REPORT DOCUMENTATION PAGE		READ INSTRUCTIONS BEFORE COMPLETING FORM
1. REPORT NUMBER	2. GOVT ACCESSION NO.	3. RECIPIENT'S CATALOG NUMBER
4. TITLE (and Subtitle) A PRELIMINARY HUMAN ENGINEERING EVALUATION OF HYPERBARIC CONTROL SYSTEMS.		5. TYPE OF REPORT & PERIOD COVERED Medical Research Progress Report.

**A PRELIMINARY HUMAN ENGINEERING EVALUATION
OF HYPERBARIC CONTROL SYSTEMS**

The information to be reported emanates from a preliminary evaluation dealing with human factors design adequacy of hyperbaric control/displays developed for the hyperbaric research facility. Although the control-panel designs had been approved and fabrication was underway, a preliminary review of the engineering diagrams for the control panel revealed that the existing designs might contribute significantly to decrements in overall system performance: a thorough human factors engineering analysis appeared to be required. The scope of this report is limited to an analysis of the instrumentation/man interface.

Fig. 23. The right console mock-up was constructed from contractors' plans; the left is a modification based on preliminary human factors studies.

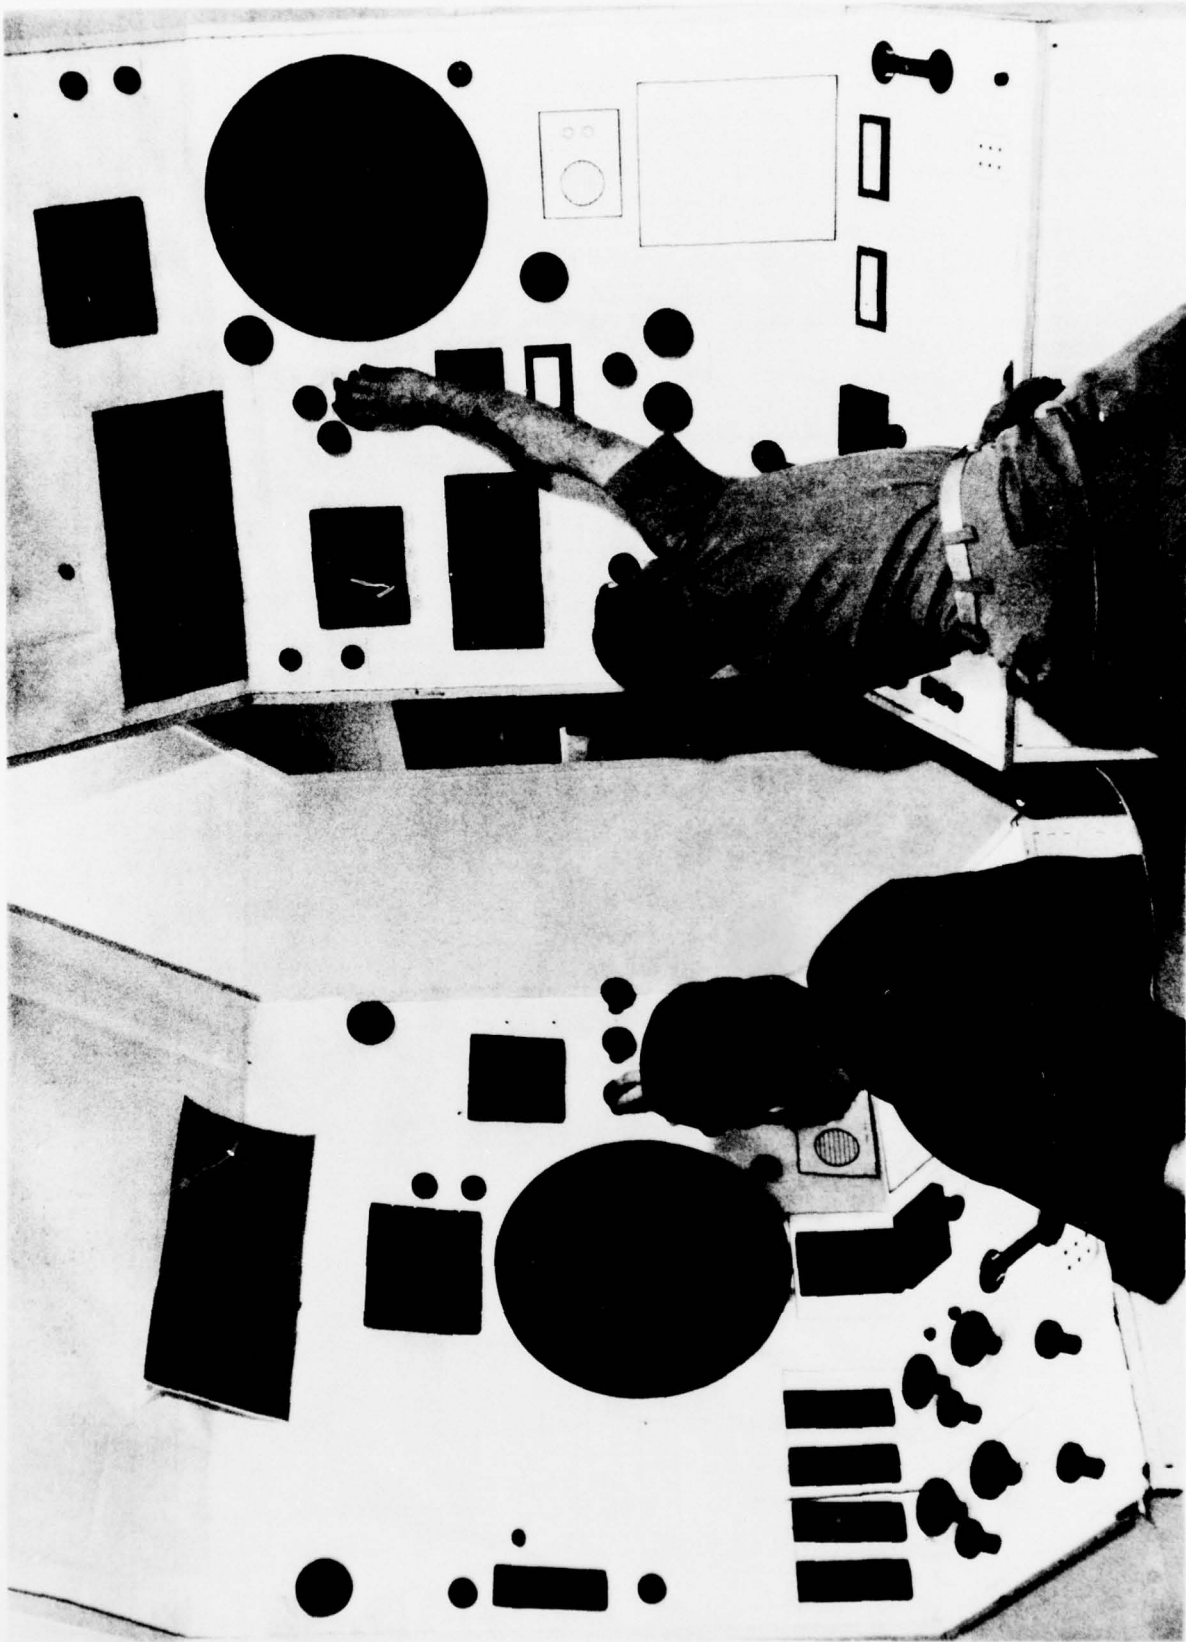
If attention is not focused on these issues, it is likely that the control system will offer less than its intended efficiency and purpose. That purpose is to provide smooth, reliable, and safe operation of the equipment and to insure the success of the mission. The control panel on the left of Fig. 23 is one of many alternate designs that are currently being compared with the contractor-supplied panel design (right side of Fig. 23). Notice the degree of body and hand movement required of the seated operator on the right for activation of the oxygen manifold. The operator on the left, however, has no difficulty in reaching 96% of the manual controls on his panel. Comparisons such as these will lead eventually to increased efficiency in operation and to over-all safety.
